Service Bulletin

SEB00-1

DOORPOST MAPLIGHT SWITCH INSULATOR INSPECTION

Figure 1. Doorpost Maplight Switch Insulator
Inspection

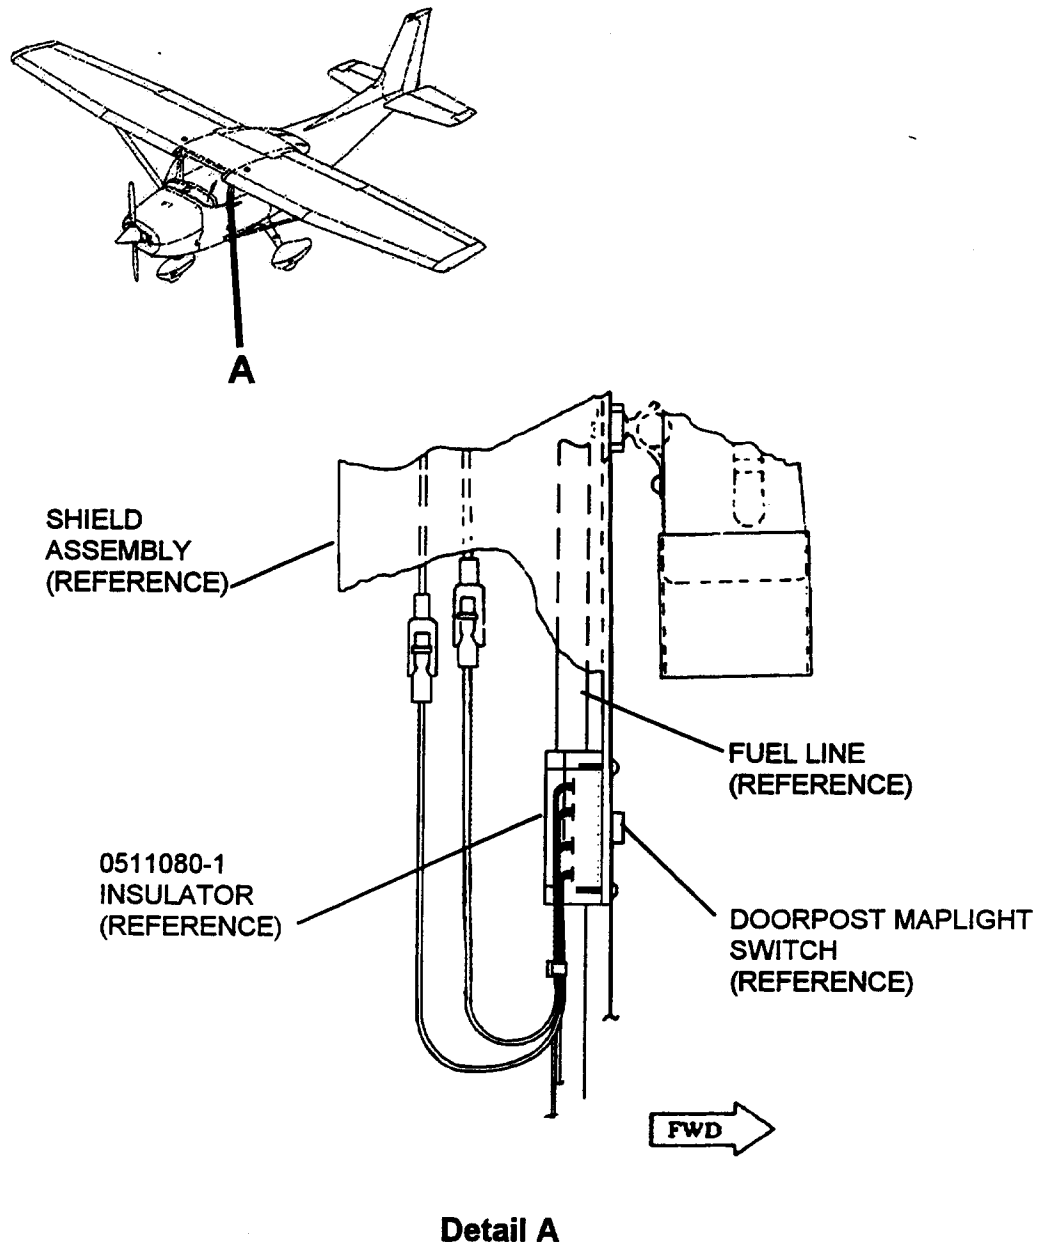
1. Inspect Doorpost Maplight Switch Insulator.
 - A. (Refer to Figure 1.) Remove Shield Assembly from left forward doorpost far enough to gain access to switch assembly.

- B. (Refer to Figure 1.) Verify presence and condition of 0511080-1 Insulator attached to Doorpost Maplight Switch as shown.
 - (1) If 0511080-1 Insulator is not installed or if it is damaged in any way, install a new 0511080-1 Insulator as follows:

- a. Loosen screws and nut enough to slip the slotted ends of the insulator under the switch assembly.
 - b. Secure switch assembly and insulator to shield assembly with screws and nuts. Proceed to step B. (3).

- (2) If the 0511080-1 Insulator is installed and in good condition, proceed to step B. (3).
 - (3) If fuel lined is damaged in any way, replace fuel line.
